# Access Compliance Report

## Public Rights-of-Way

### (Curb Ramps)

Intersection ID: 5508	Main Street: THOMAS_COMBS_DR	Cross Street: UNIVERSITY_CITY_BV	Location: NW
ADA ID: 4B29C6FC345B	Ramp Type: Perp	Initial Pass/Fail: Fail	Overall Compliance: No
Severity Score: 25			
Codes/Mitigation Info/Possible Solution		Field Measurements/Component Compliance

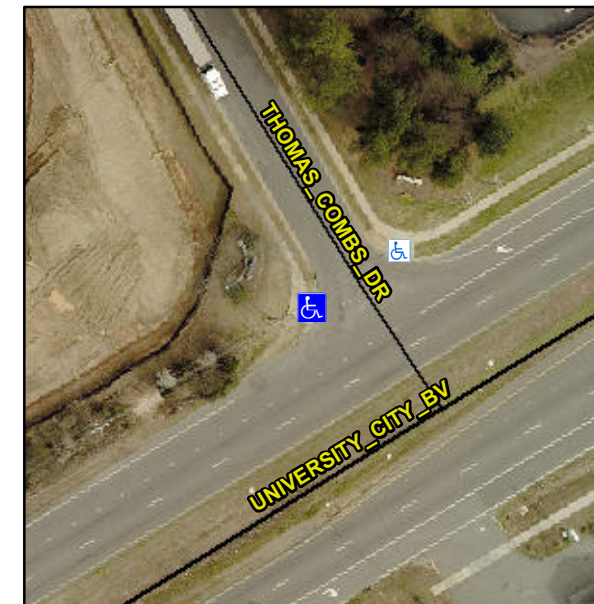
**Remove & Replace Entire Ramp.**

**Not Found, R304.2.2**

Compliance	Description	Data	Compliance	Description	Data
N/A	Ramp Length (in)	95.0	No	Ramp Slope (%)	20.0
Yes	Ramp Width (in)	48.0	Yes	Ramp XSlope (%)	0.5
N/A	Flare Type LT	N/A	N/A	Flare Type RT	N/A
N/A	Flare Slope LT (%)	N/A	N/A	Flare Slope RT (%)	N/A
N/A	Flare Traversable LT?	N/A	N/A	Flare Traversable RT?	N/A
N/A	Landing Length (in)	N/A	N/A	DWS Provided?	N/A
N/A	Landing Width (in)	N/A	N/A	DWS Contrast?	N/A
N/A	Landing Slope (%)	N/A	N/A	DWS Length (in)	N/A
N/A	Landing X Slope (%)	N/A	N/A	DWS Full Width?	N/A
N/A	Landing Curb? (Y/N)	N/A	N/A	DWS Offset (in)	N/A
N/A	Shared Landing?	N/A			
N/A	Gutter Ponding?	N/A	N/A	Gutter Slope (%)	N/A
N/A	Gutter Lip Ht (in)	N/A	N/A	Gutter X Slope (%)	N/A
N/A	Painted X Walk1?	No	N/A	Painted X Walk2?	N/A
	X Walk 1 Direction	To NE		X Walk 2 Direction	N/A
N/A	X Walk 1 Width (in)	N/A	N/A	X Walk 2 Width (in)	N/A
	X Walk 1 Slope (%)	0.0		X Walk 2 Slope (%)	N/A
	X Walk 1 X Slope (%)	0.3		X Walk 2 X Slope (%)	N/A
